**FINAL REMEDIAL DESIGN REPORT
FINAL REMEDY**

**AMERICAN CHEMICAL SERVICE SUPERFUND SITE
GRIFFITH, INDIANA**

Re: Final RD Report
ACS NPL Site, Griffith, Indiana

SHEET
C-16

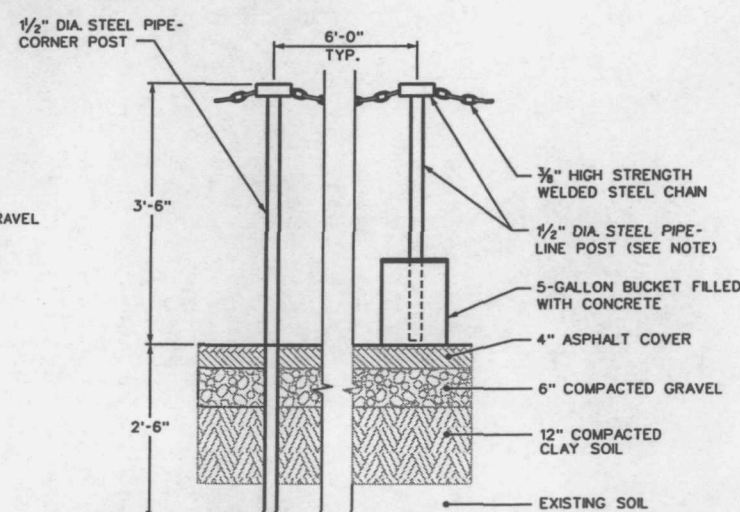
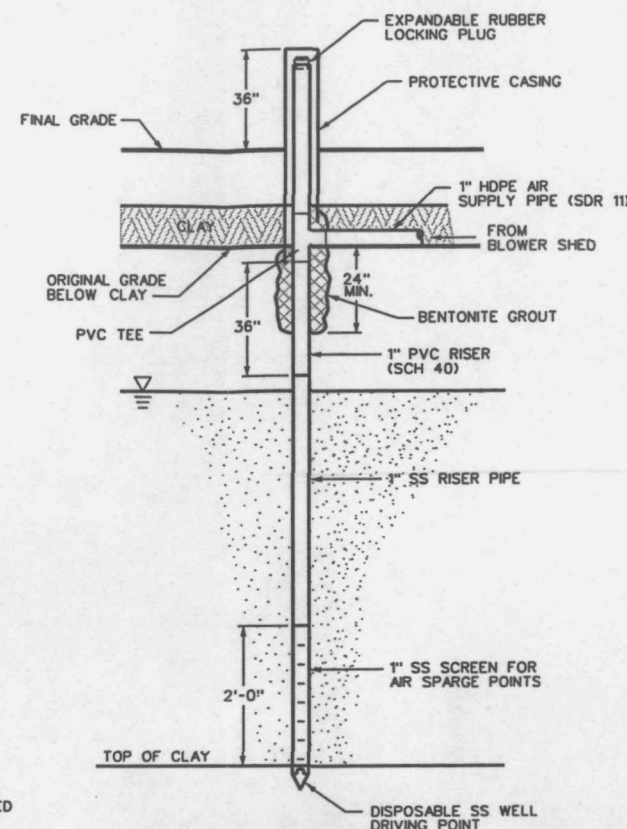
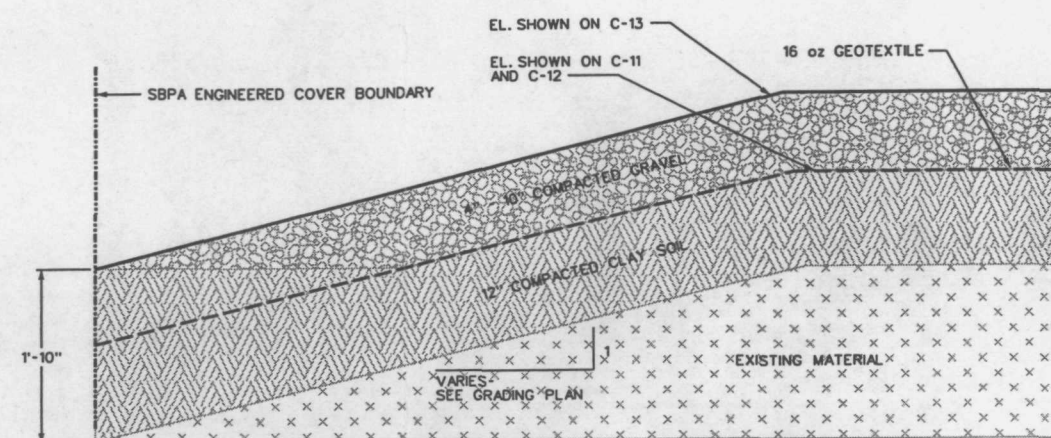
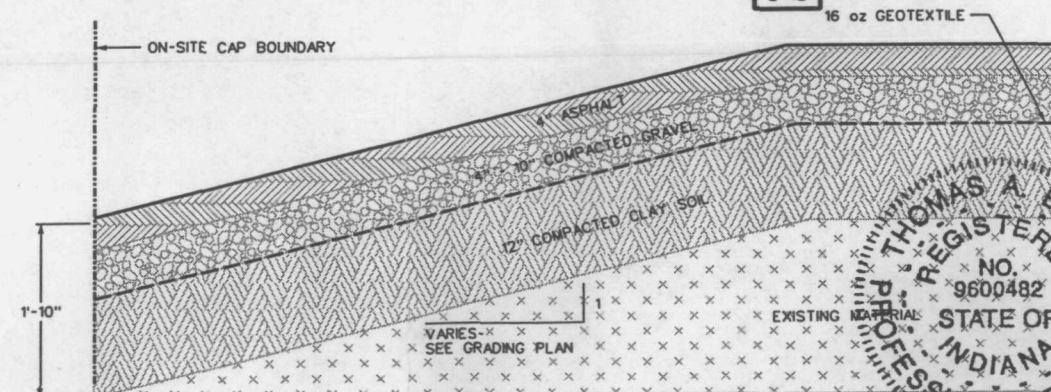
Comment A13. Drawing C-16, Section A: Delete call-outs for Drawings C-4 and C-7 or define this section on those drawings.

Comment A14. Drawing C-16, Section B: Delete call-out for Drawing C-7 or define this section on that drawing.

The call outs for Drawings C-4 and C-7 have been deleted on Drawing C-16, Section A.

The call out for Drawing C-7 has been deleted on Drawing C-16, Section B.

SHEET
C-12

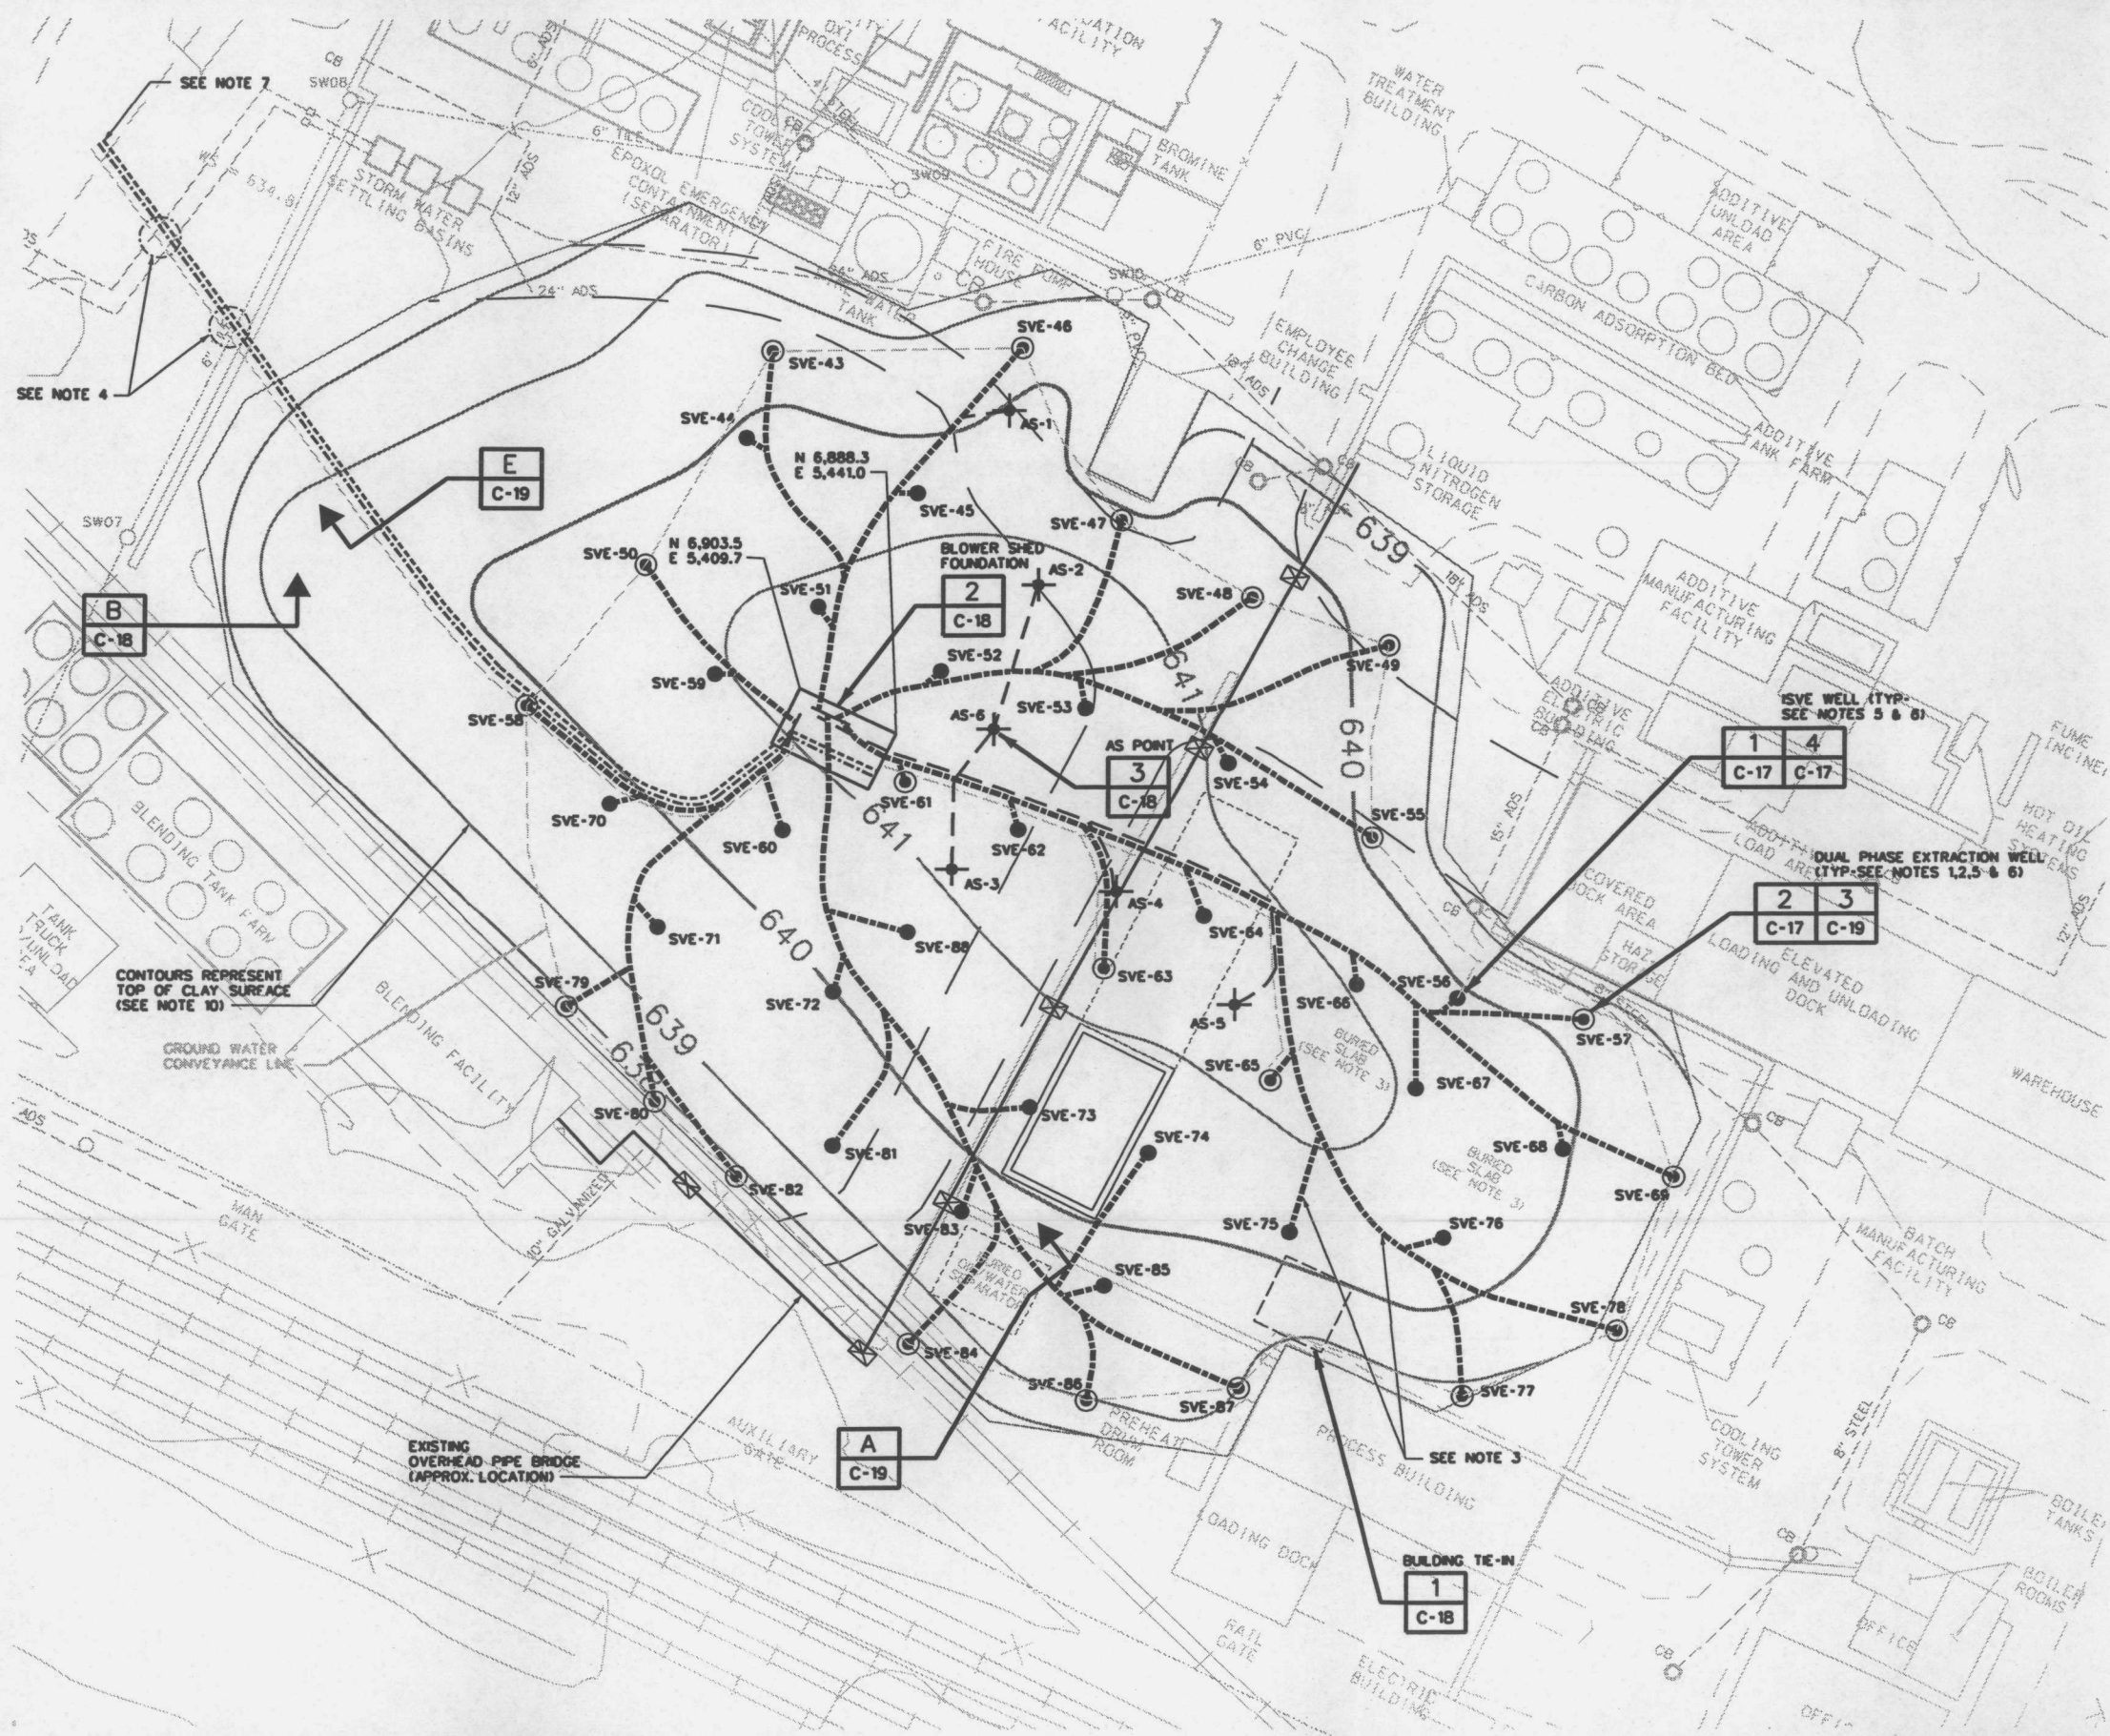
Comment A11. Drawing C-12: Define call-out for "Detail 1, Drawing C-17" on Drawing C-17.

The call out for "Detail 1, Drawing C-17" on Drawing C-17 has been defined on Drawing C-12.
